## **ADDENDUM**

**PROJECT:** Forestside Estates  
Attmar & Palleschi Drive  
Brampton, Ontario

**PROJECT NO.:** 18-017

**ADDENDUM NO.** E-3

| DATE<br><br>MAY, 2019 | PROJECT<br><br><b>18-017</b> | DRAWING<br><b>E-10</b> |

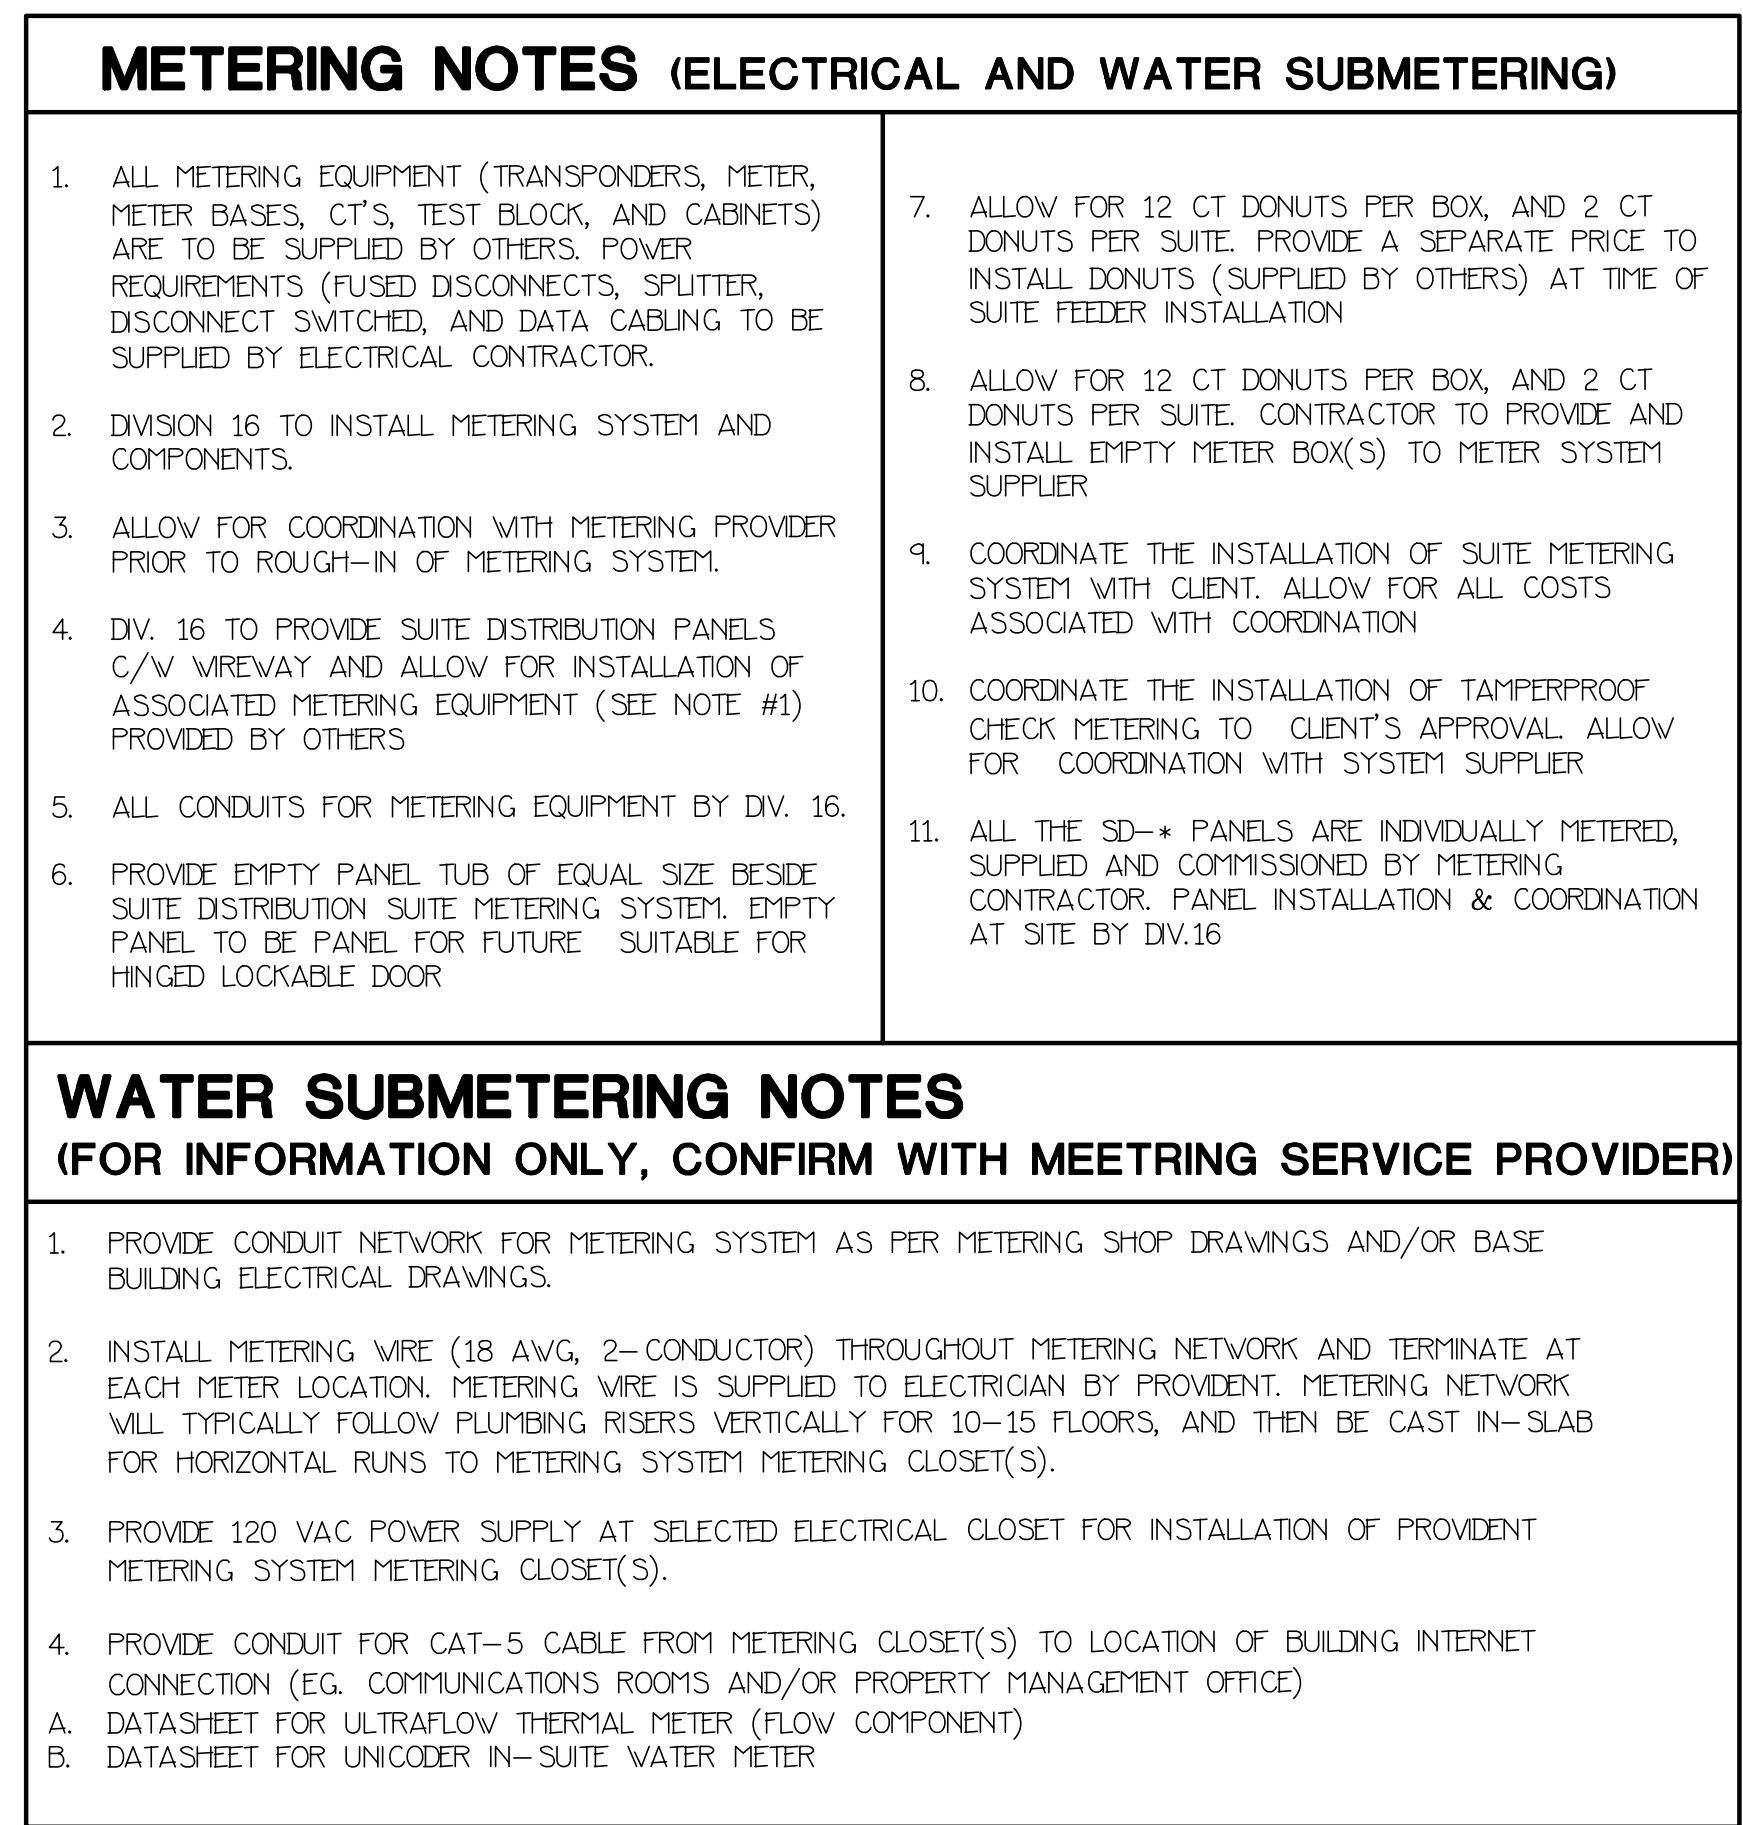
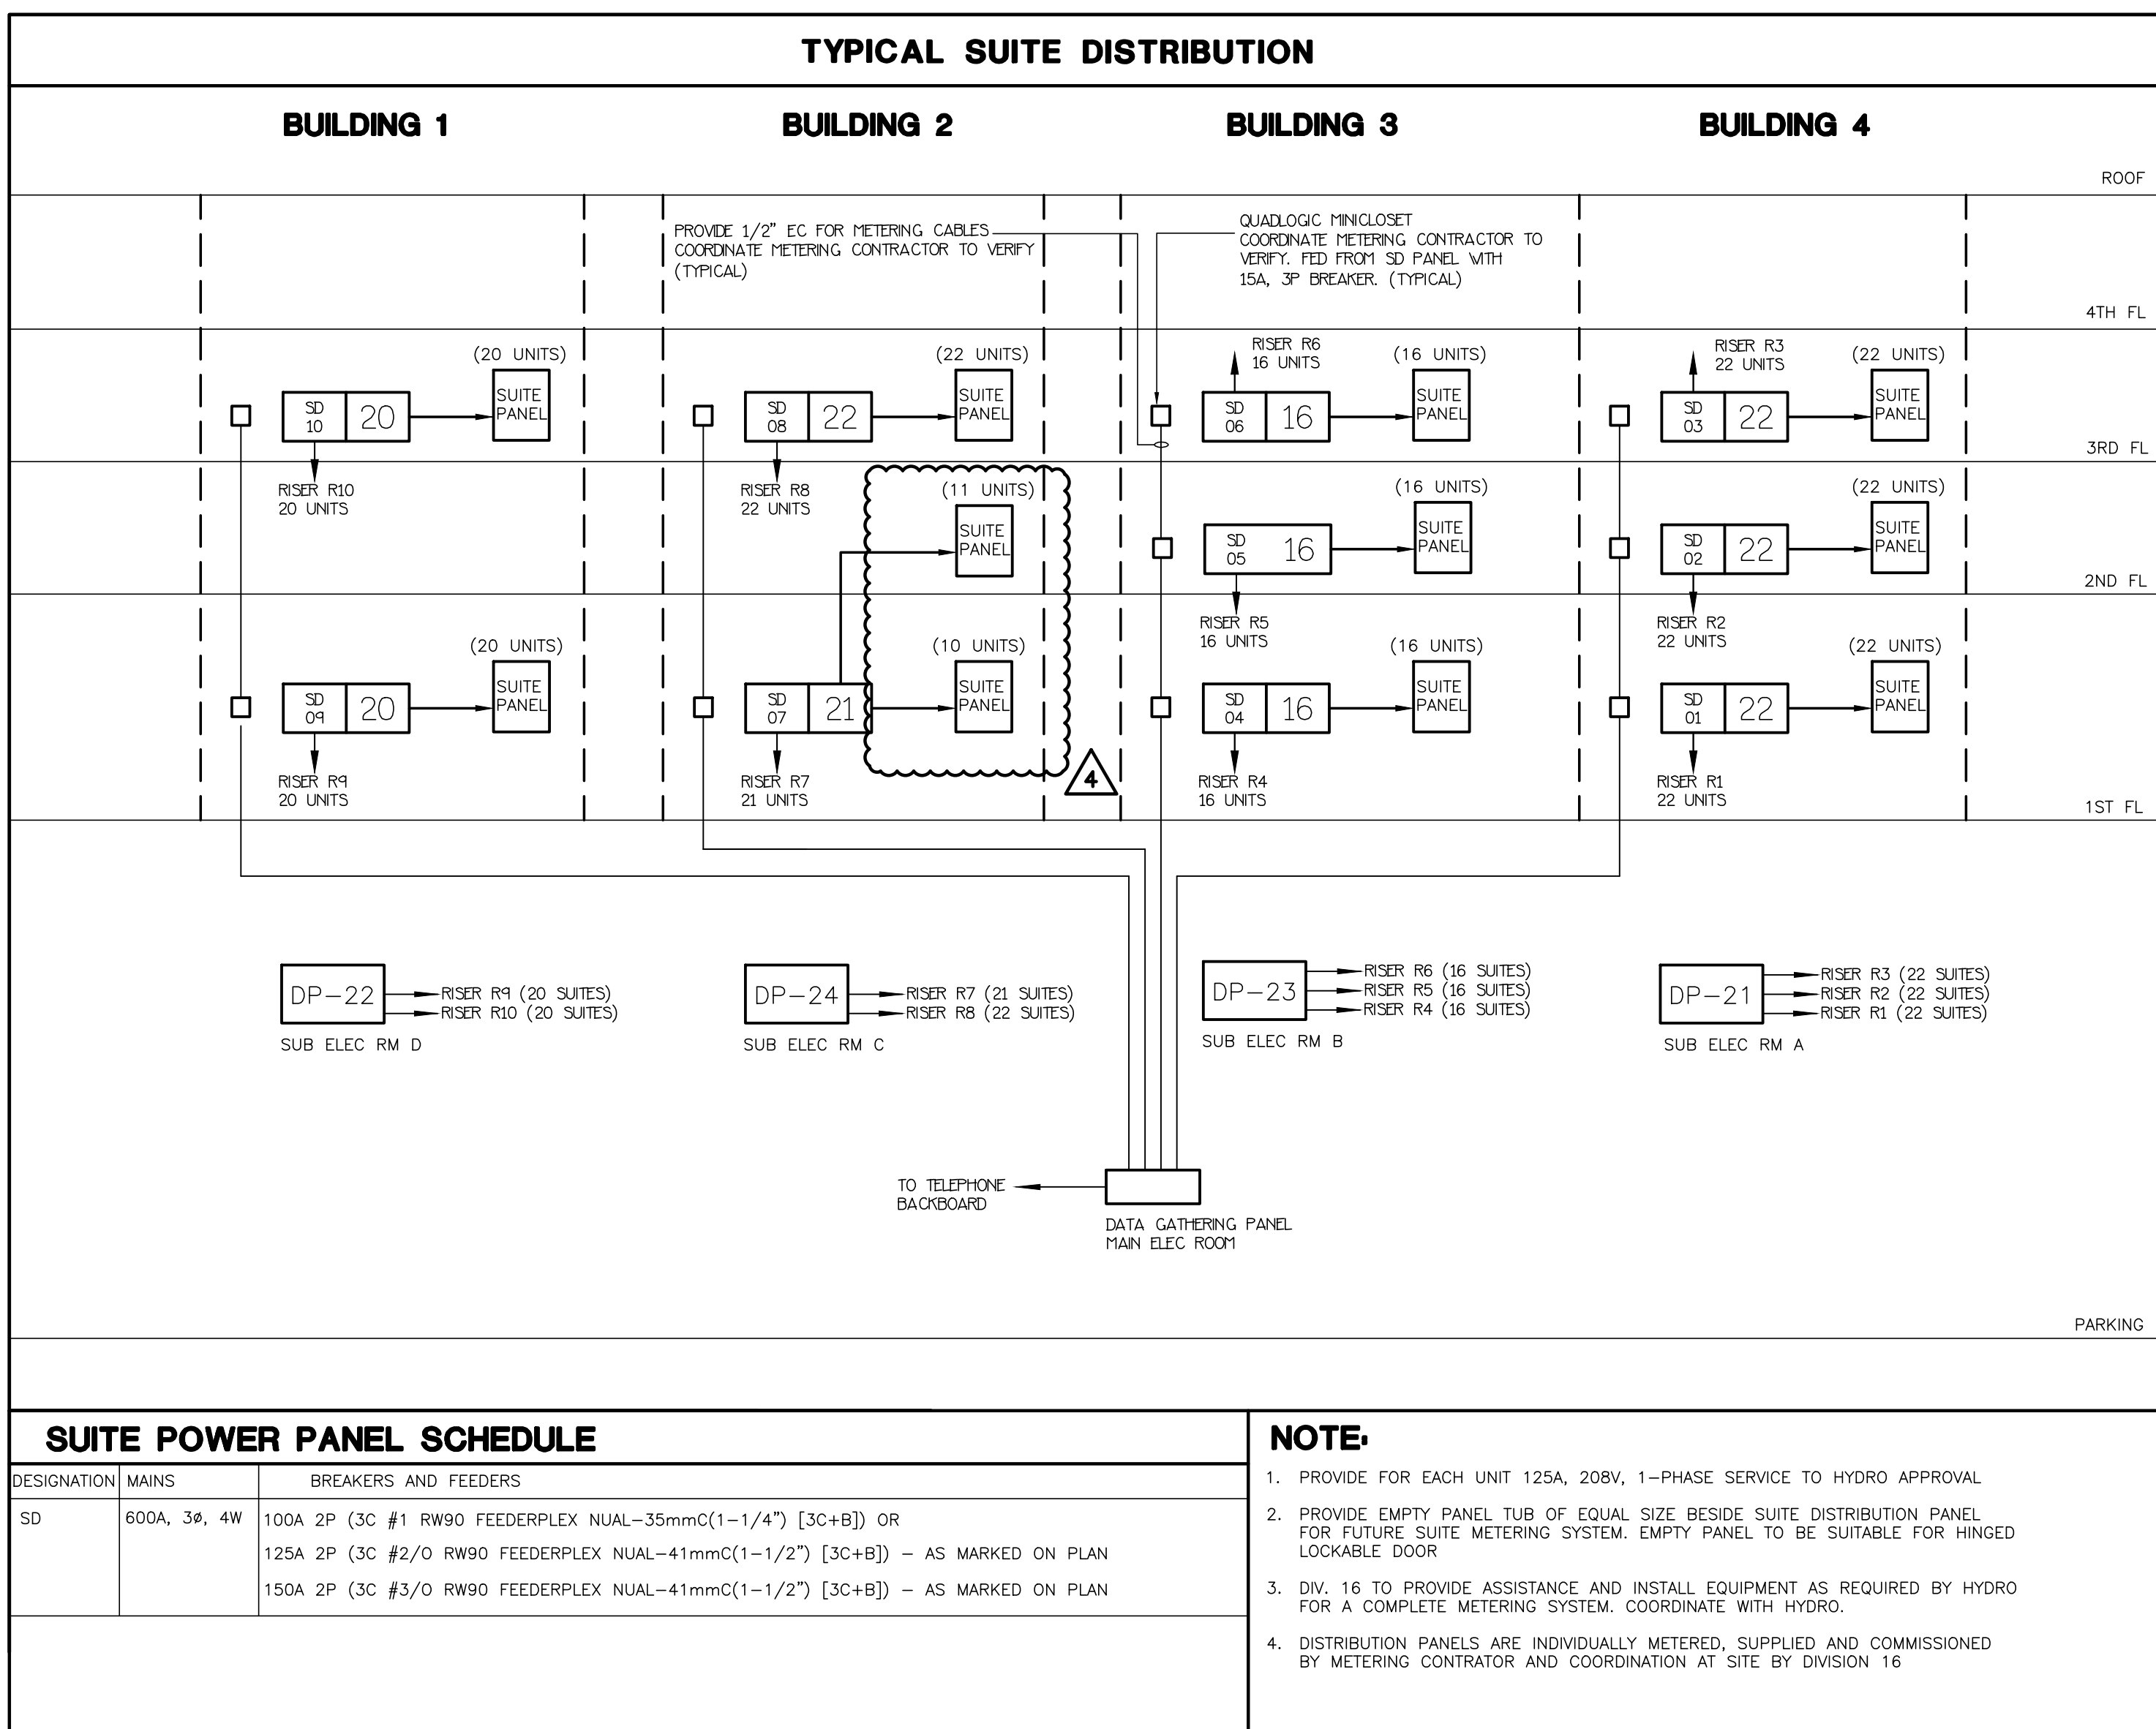
**4.0 Reference Drawings E-10 (Risers - Electrical) Issued**

4.1 Revise: Riser diagram as shown.

| TITLE                                                 |                          | FIRE ALARM SYSTEM<br>ELECTRICAL |                 |
|-------------------------------------------------------|--------------------------|---------------------------------|-----------------|
| DATE<br>MAY, 2019                                     | PROJECT<br><b>18-017</b> | DRAWING<br><b>E-11</b>          | OF<br><b>16</b> |

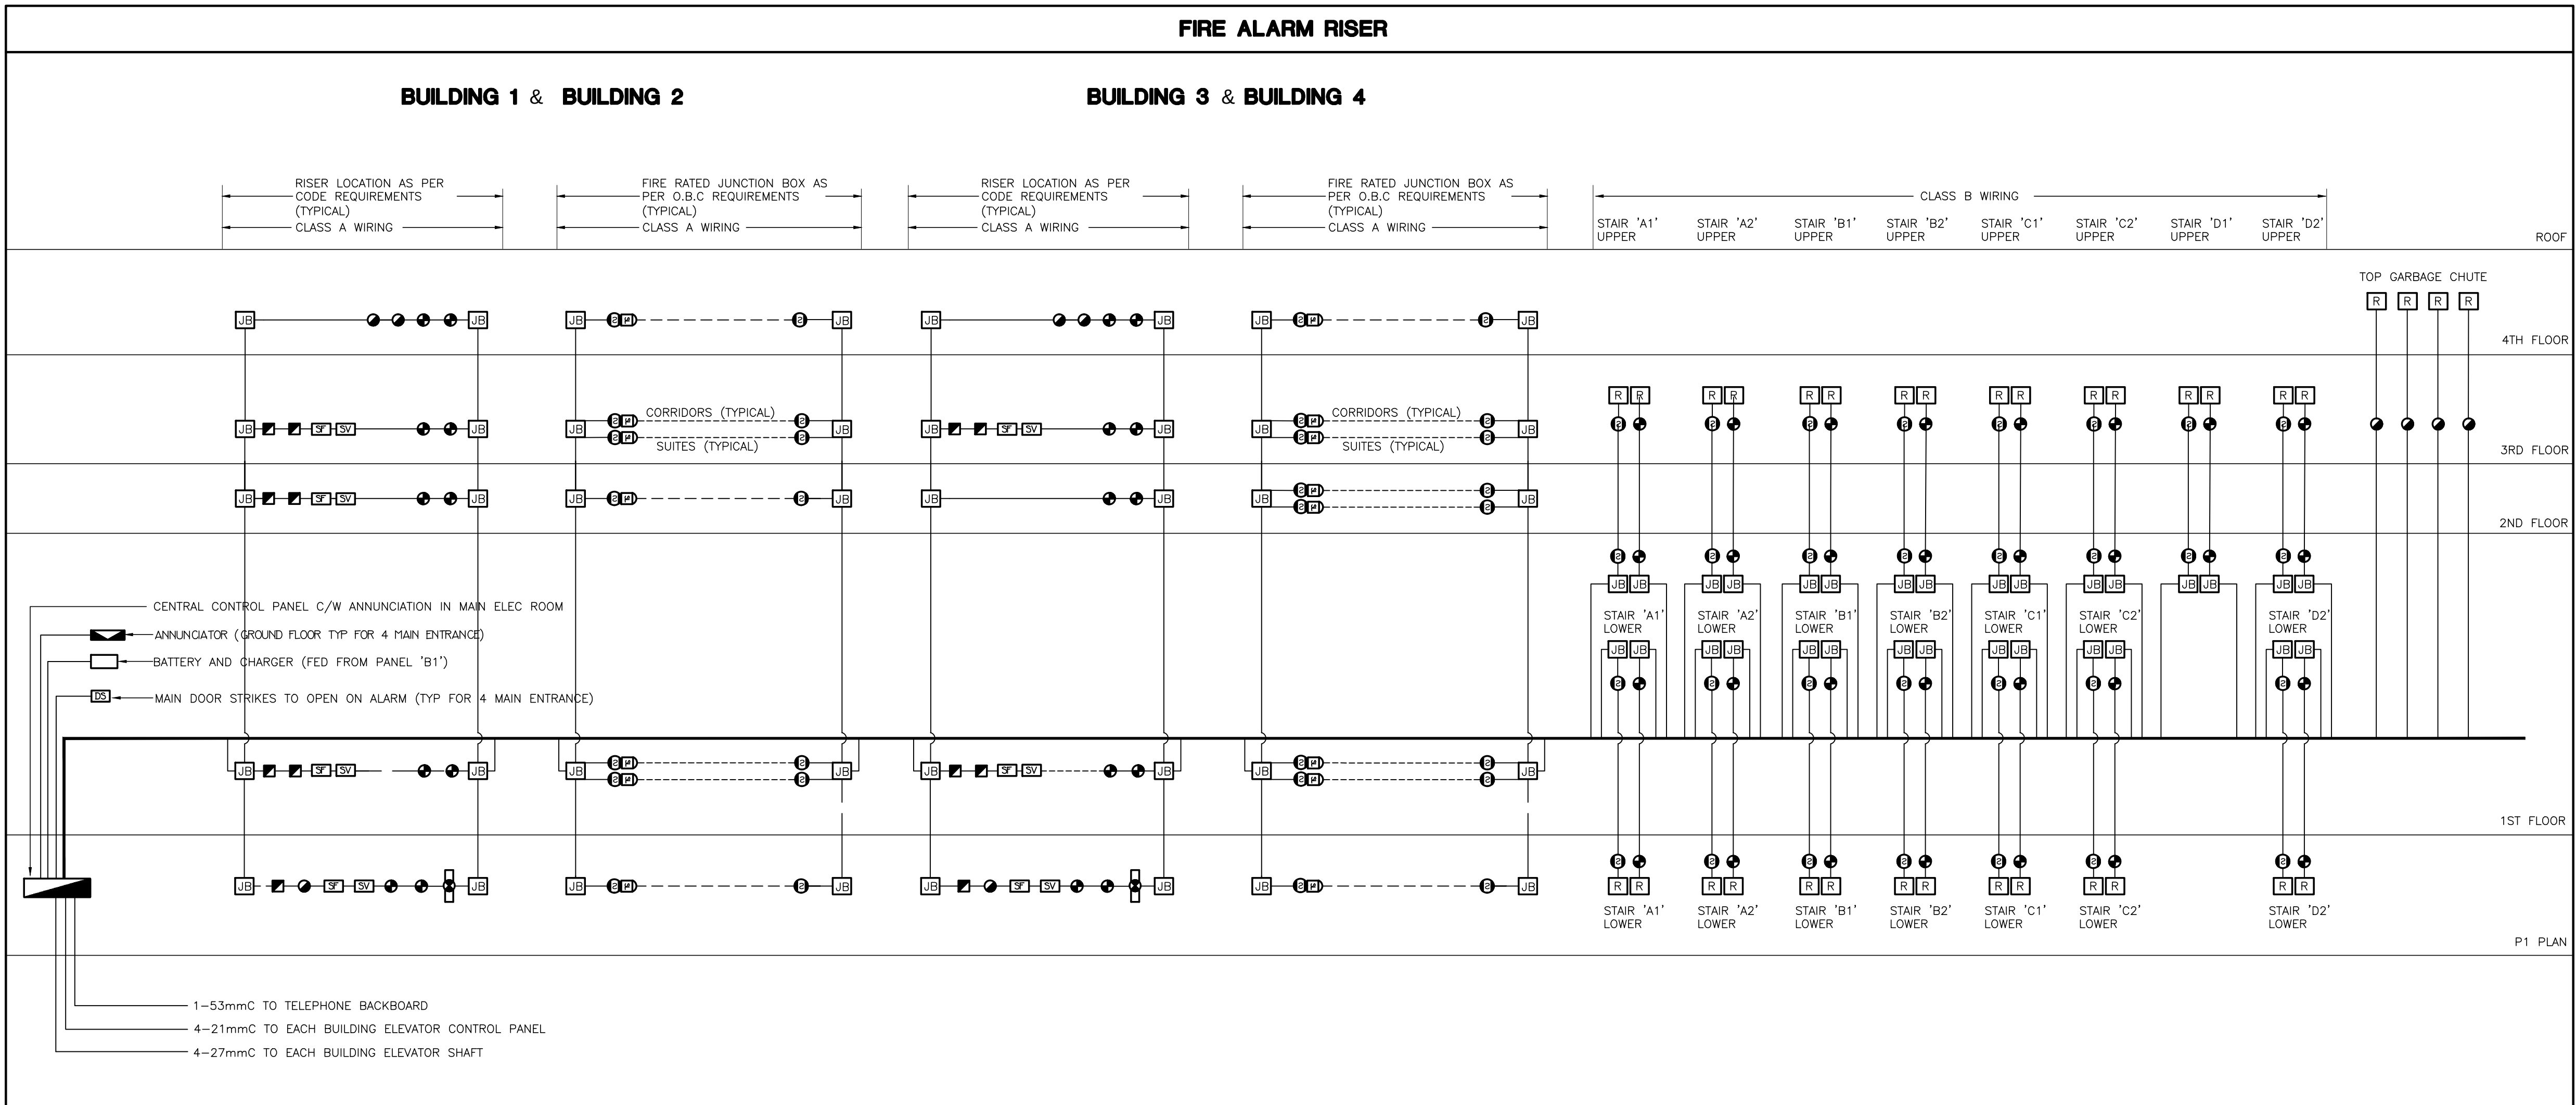
**5.0 Reference Drawings E-11 (Fire Alarm System - Electrical) Issued**

5.1 Revise: Fire alarm schedule as shown.
